50 CFR Parts 222 and 223

Endangered and Threatened Wildlife; Sea Turtle Conservation Requirements

ACTION: Proposed rule; request for comments.

1A. Standard Opening

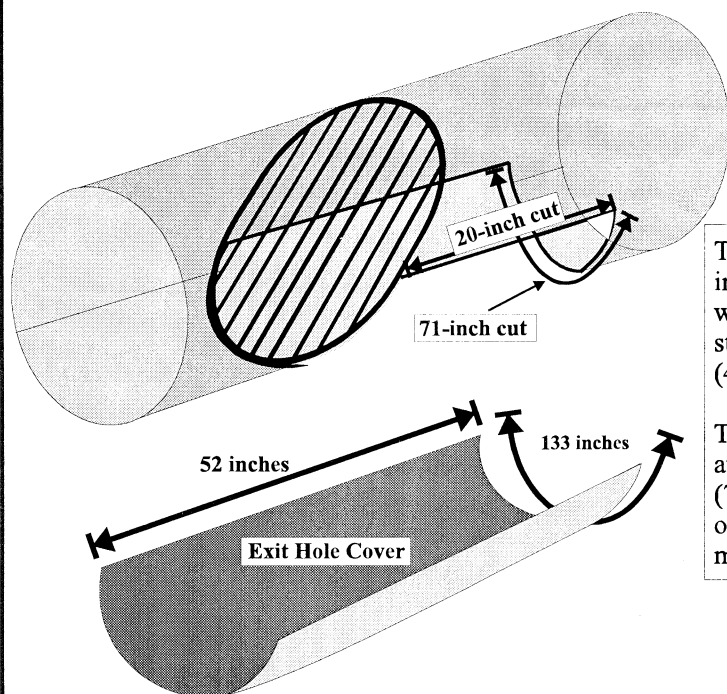
b. Add Figures 1A, 1B, and 1C to part 223.

Cut an exit hole in the extension forward of the TED frame 20 inches (51 cm) deep, on each side, by 71 inches (180 cm) across. Excess webbing is removed by cutting across $\frac{1}{2}$ mesh forward of the TED frame.

(A) *Standard opening*. The two forward cuts of the escape opening must not be less than 20 inches (51 cm) long from the points of the cut immediately forward of the TED frame. The resultant length of the leading edge of the escape opening cut must be a minimum of 71 inches (180 cm). (Figure 1A of this part illustrates the dimensions of these cuts). A webbing flap, as described in (d)(3)(i) of this section, may be used with this escape hole. The resultant opening with a webbing flap must have a minimum width of 71 inches (180 cm) straight-line stretched mesh (Figure 1C of this part). The circumference of the exit opening must be 142 inches (361 cm) when stretched.

Figure 1B. Exit Hole Cover for the Standard Opening

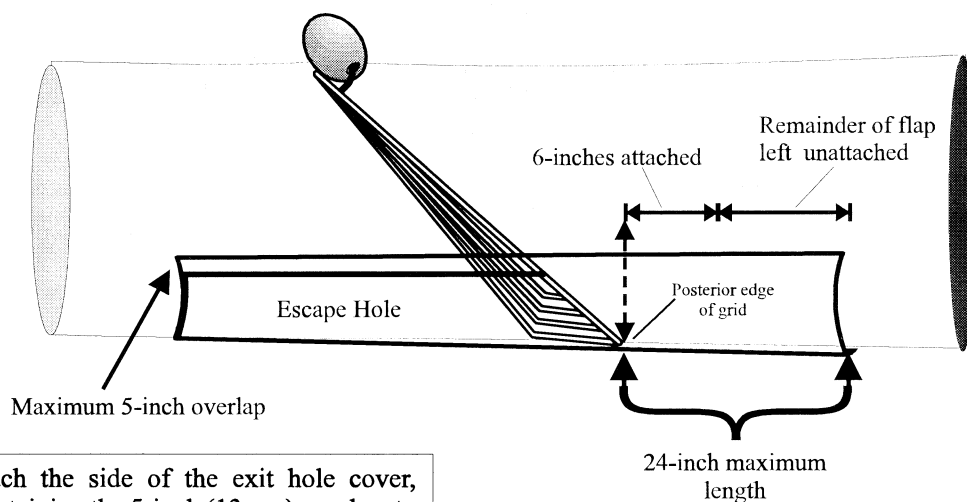
The exit hole cover is made by cutting a 133-inch (338-cm) by 52-inch (132-cm) piece of webbing no smaller than 1½-inch (4-cm) stretched mesh and no larger than 1-5/8 inch (4.2-cm) stretched mesh.

The 133-inch (338-cm) edge of the cover is attached to the forward edge of the opening (71-inch (180-cm) edge). The cover should overlap the exit hole on each side by no more than 5-inches (13-cm).

Attach the side of the exit hole cover, maintaining the 5-inch (13-cm) overlap, to the side of the escape opening by sewing 22-inches (56-cm) of the cover to 20-inches (51-cm) of the opening forward of the TED frame. Behind the TED frame, sew an additional 15-inches (38-cm) of the cover to 15-inches (38-cm) of the extension.

The cover may extend no more than 24-inches (61-cm) behind the posterior edge of the TED frame.

(i) *Standard TED flap*. The flap must be a 133-inch (338-cm) by 58-inch (148-cm) piece of webbing. The 133-inch (338-cm) edge of the flap is attached to the forward edge of the opening (71-inch (180-cm) edge). The sides of the flap may overlap the exit hole on either side by no more than 5 inches (13 cm). The flap may extend no more than 24 inches (61 cm) behind the posterior edge of the grid (Figure 1B illustrates this flap).

Figure 1C. Completed Standard TED Opening

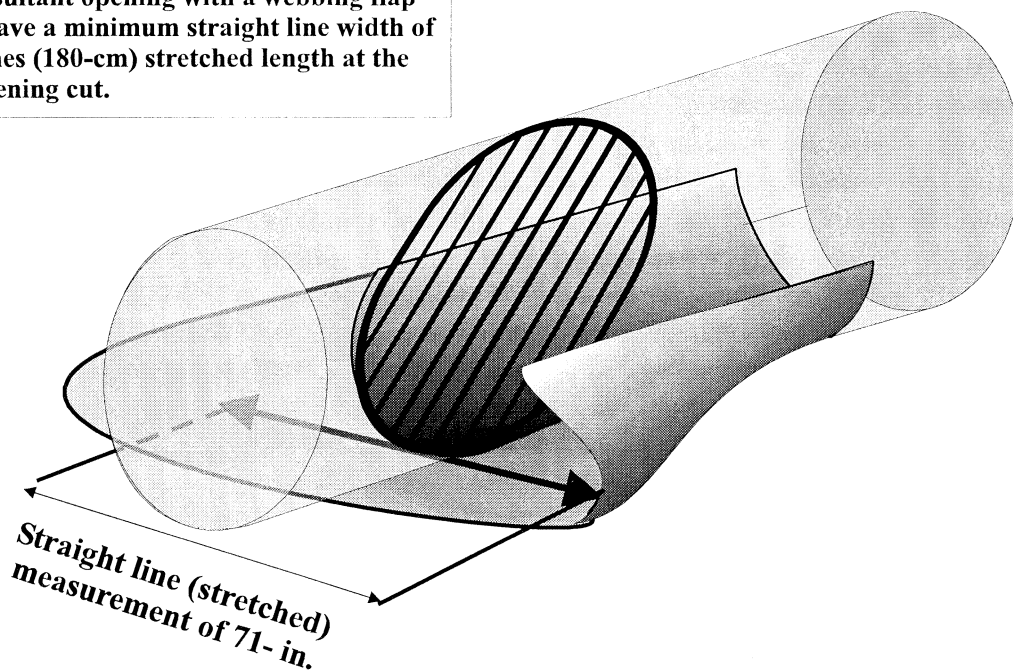
The resultant opening with a webbing flap must have a minimum straight line width of 71-inches (180-cm) stretched length at the exit opening cut.

Figure 11. Standard Minimum Grid Size

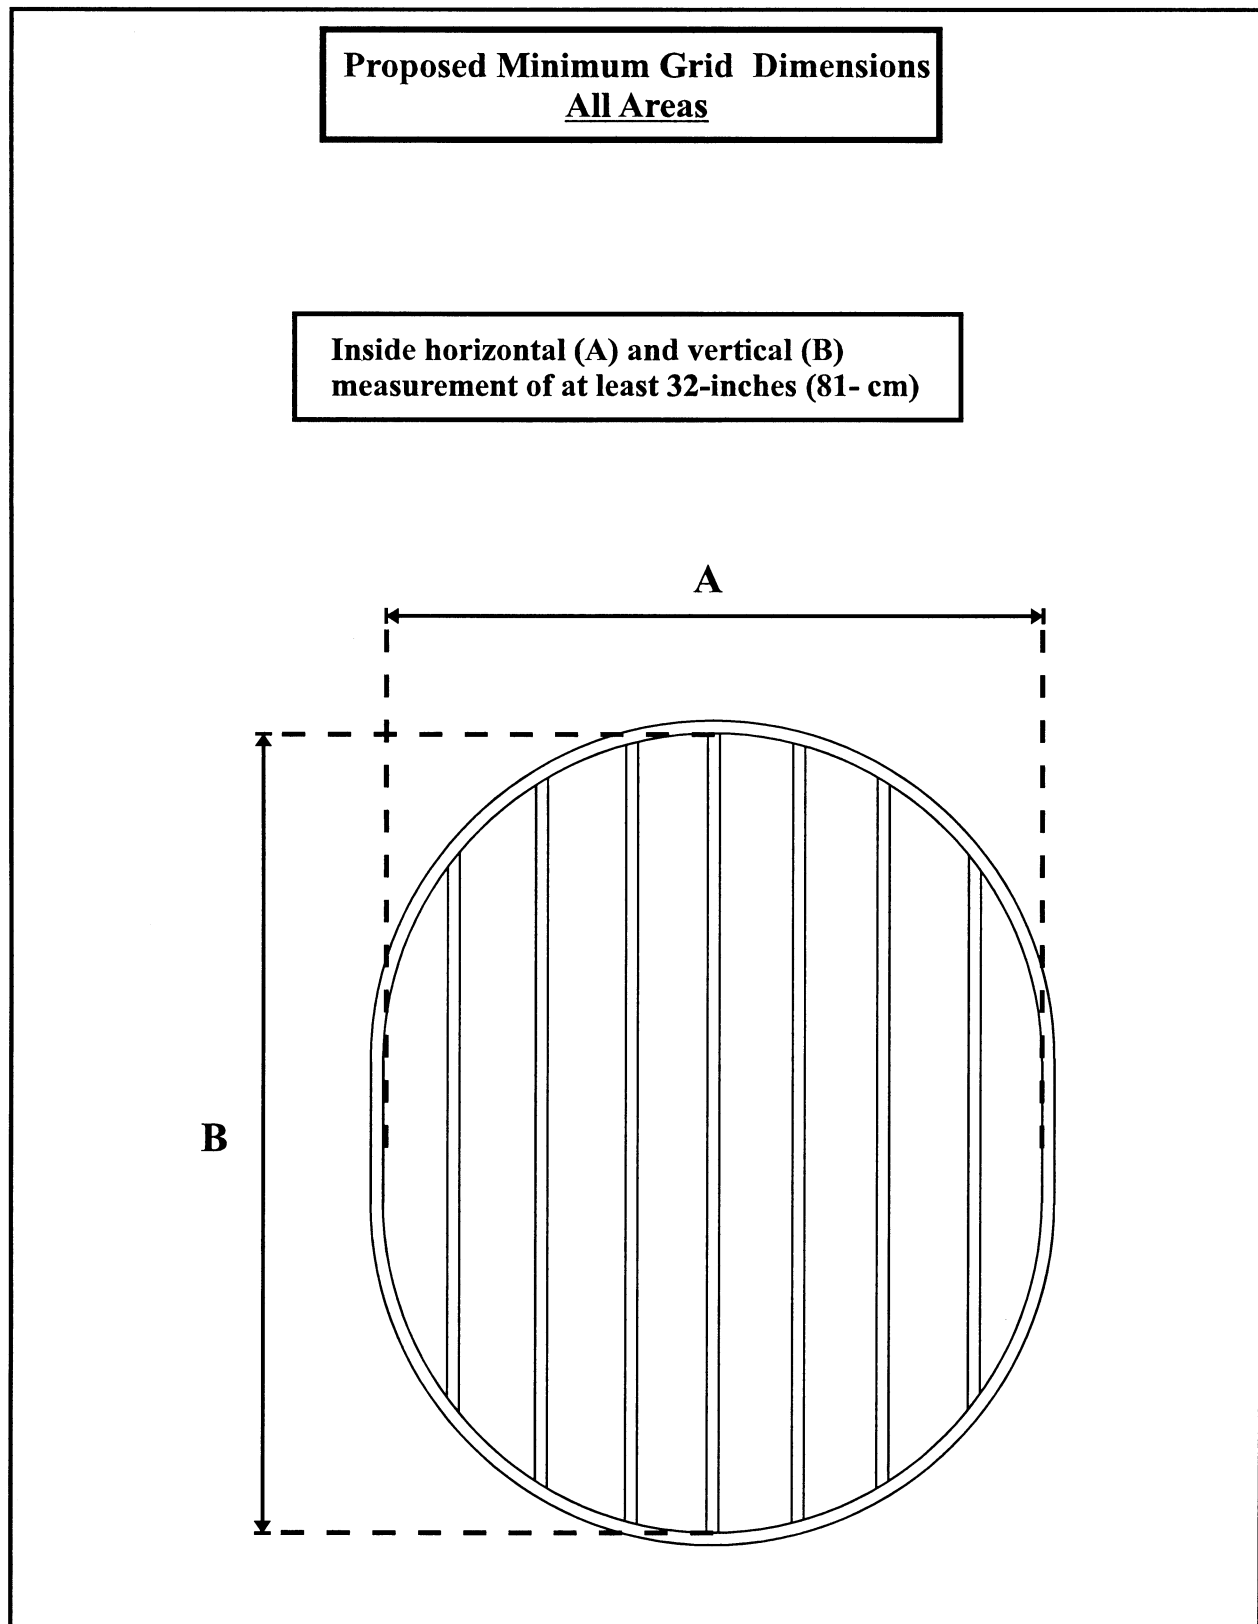
c. Revise Figure 11 to read as follows:

(i) *Single-grid hard TED*. A single-grid hard TED must have a minimum inside horizontal and vertical measurement of 32 inches (81 cm). The required inside measurement must be at the mid-point of the deflector grid.
